Brisbane Central Business District Bicycle User Group

Please accept the below as our submission regarding the development on 17 Skyring Terrace, Teneriffe with the application number A006375195. As per standard CBD BUG practice our comments are limited to issues regarding people getting about via active transport and how they will be impacted by any project. Due to the binary nature of the Brisbane Development Application feedback, we currently **oppose** the development due to its poor provision for the missing section of the Riverwalk at the forementioned location.

Figure 3 – Development application – Landscape section

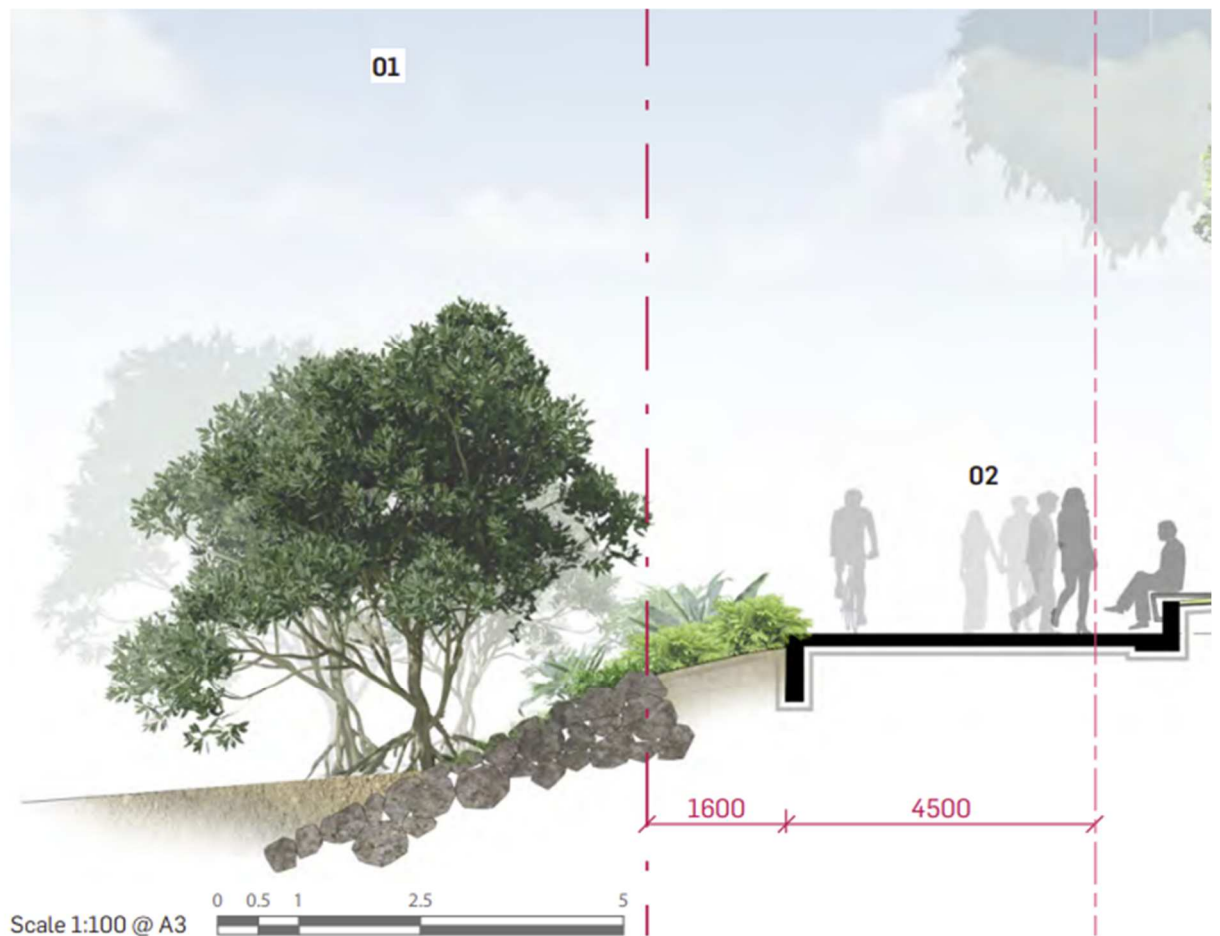
The CBD BUG is bitterly disappointed with the proposal as outlined in the documents supplied in the development application to Brisbane City Council. According to the Landscape plans submitted the riverwalk path will have a usable width of 4.5m (figure 3). This is a contradiction of the Town Planning report that states "6m Riverwalk corridor" (figure 4). Unless the developer intends people to walk on landscaping, to claim they have provided a "6m Riverwalk corridor" is a misrepresentation. An effective width of 4.5m would be even less than other recent developments (Macquarie One and Pier Waterfront) along this corridor that provided paths of approximately 5.5m.

Neither the Landscape Plans nor the Town Planning Report clarify how the riverwalk will function, or whether it will be segregated or shared. Based on the document's images it can be concluded that the riverwalk will be shared. This is highly disappointing as this is not in accordance with both TMR and Austroads guidelines namely "Figure 5.4" (figure 5), which is shared between both guidelines. Further to this the CBD BUG has followed TMR guidance (following an on site patronage count) on how a path should be selected (figure 6), and this once again advises the path should be segregated.

As stated above the CBD BUG is disappointed with what is currently being proposed. We call on the council to reject the current proposal and require the developer to provide a minimum 6m clear path width (no obstructions including street furniture) riverwalk that is in compliance with TMR and AustRoads Guidelines. Patronage along this corridor will naturally continue to grow as more people move into the area and the network effective that will occur once this missing section is delivered.
